**YUCCA MOUNTAIN - REQUEST FOR ADDITIONAL INFORMATION - VOLUME 2,
CHAPTER 2.1.1.5, SET 2 (DEPARTMENT OF ENERGY'S SAFETY ANALYSIS REPORT
SECTION 1.8) – Consequence Analyses**

RAI Volume 2, Chapter 2.1.1.5, Second Set, Number 6:

RAI: 2.2.1.1.5-2-006

Figure 1. Comparison of Calculated and Measured Radionuclide Concentrations for Dose-Significant Cesium Fission Products

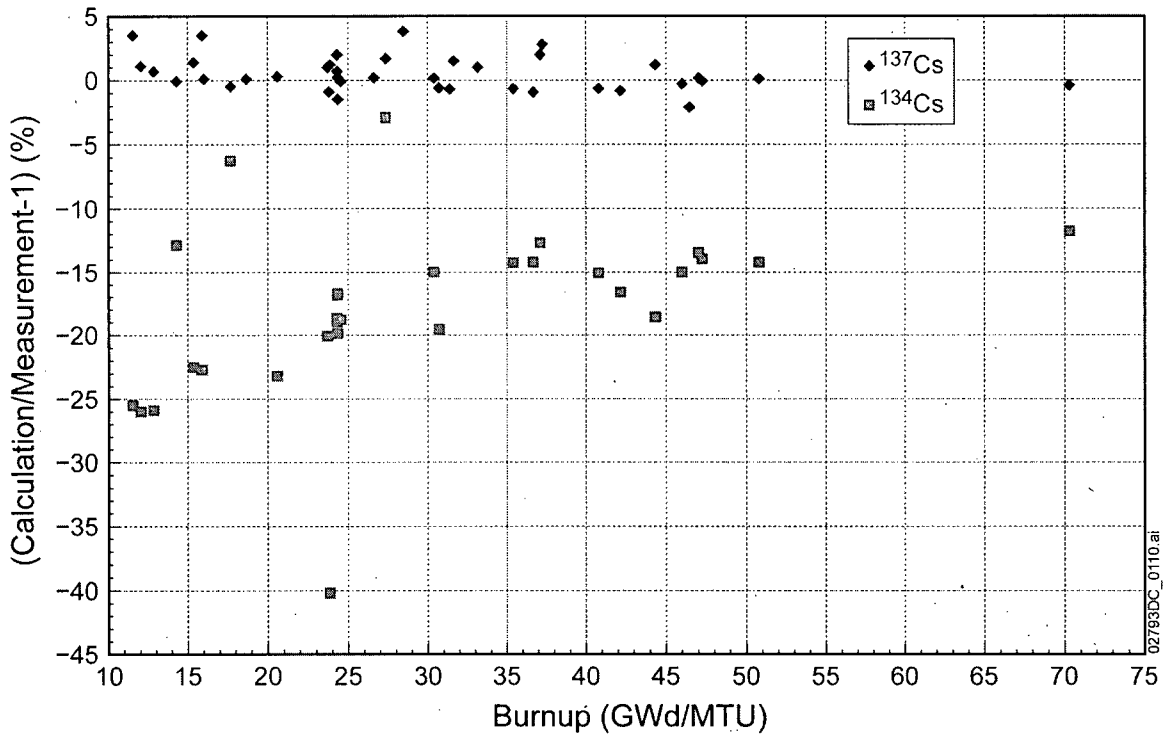
Justify the use of SCALE/ORIGEN-S (SAR Section 1.10.3.2) in source term evaluations for high-burnup spent nuclear fuel (SNF) (e.g., maximum PWR CSNF assembly with 80 GWd/MTU, or maximum BWR CSNF assembly with 75 GWd/MTU (SAR Table 1.8-2)). The SCALE/ORIGEN-S cross-section library validation is currently limited to 47 GWd/MTU (NRC, 2003).

The differences between calculated and measured radionuclide concentrations as a function of burnup are shown in Figure 1 for dose-significant cesium fission products and in Figure 2 for dose-significant actinides. Comparisons of calculated and measured isotopic concentrations (Hermann et al. 1995; Dehart and Hermann 1996; NRC 2003; Ilas and Gauld 2008) show good agreement between predicted and measured values for dose-significant radionuclides over a wide range of burnup values from 11 to 70 GWd/MTU. There is no divergence of the differences between calculations and measurements with increasing burnup and no indication that divergence should be expected at burnup values as high as 80 GWd/MTU.
